FCC Authorization

FCC Class II Permission change for FCC ID: 2AH25T5810

Subject: Description of Permissive Change

Dimensional drawing: Without scan coder

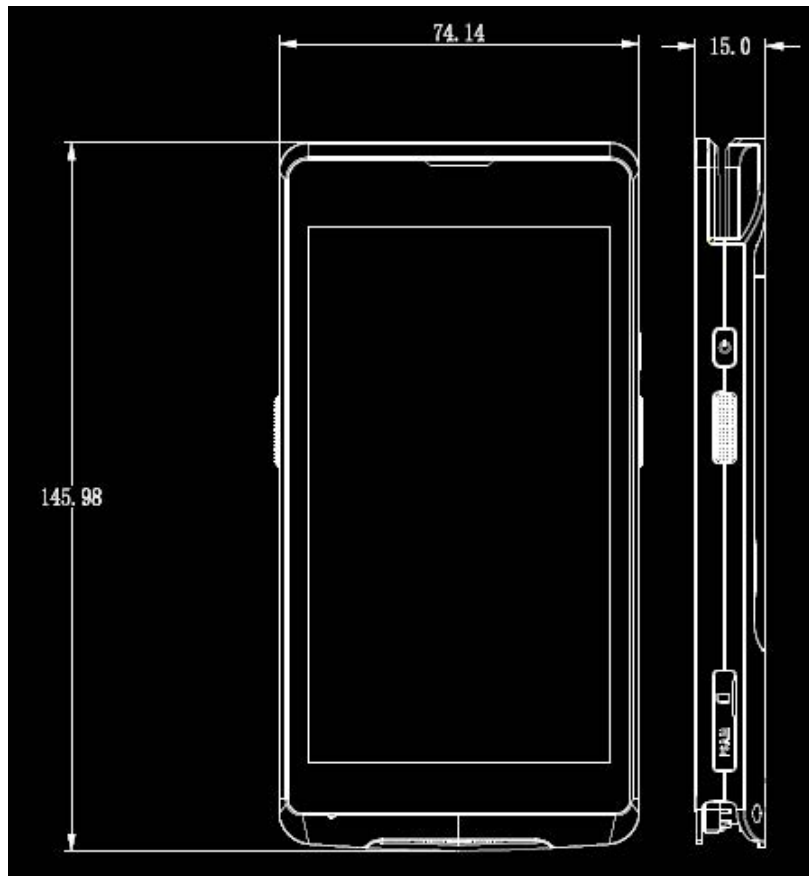
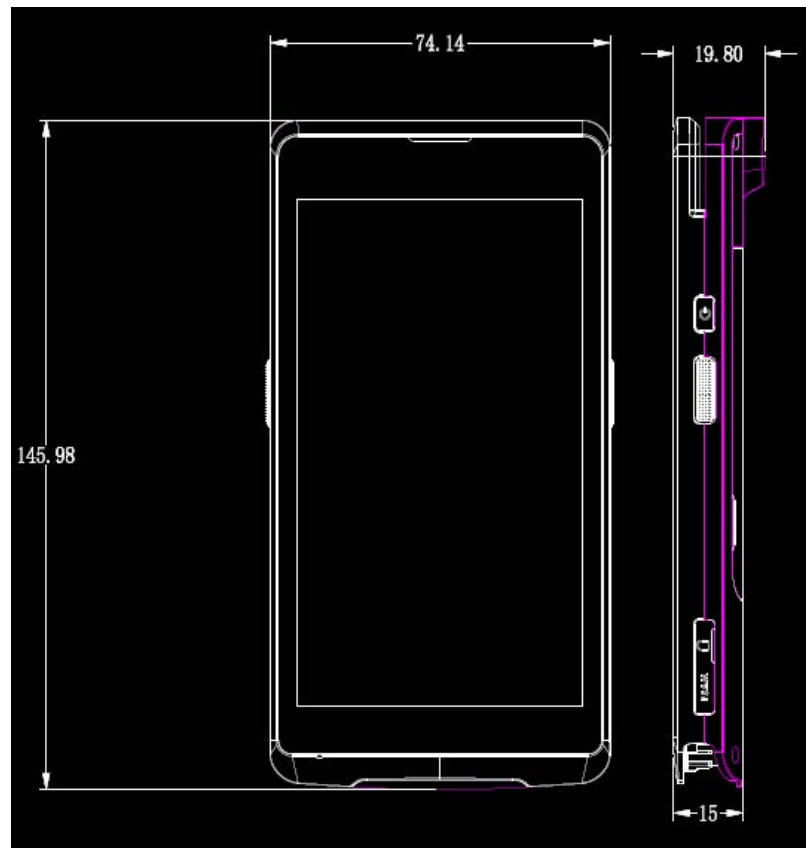
Differences between two types	without scan coder	with scan coder
WLAN and GPS antenna model	SH19453IB83-1	SH-045-016-OK-A
LTE DIV Antenna model	SH19453IA68	SH-045-017-10-OK-A
Dimensions	Length: 145.98mm Width: 74.14mm Thickness: 15.0mm	Length: 145.98mm Width: 74.14mm Thickness: 19.8mm(Scan coder part) Thickness: 15.0mm(Other part)
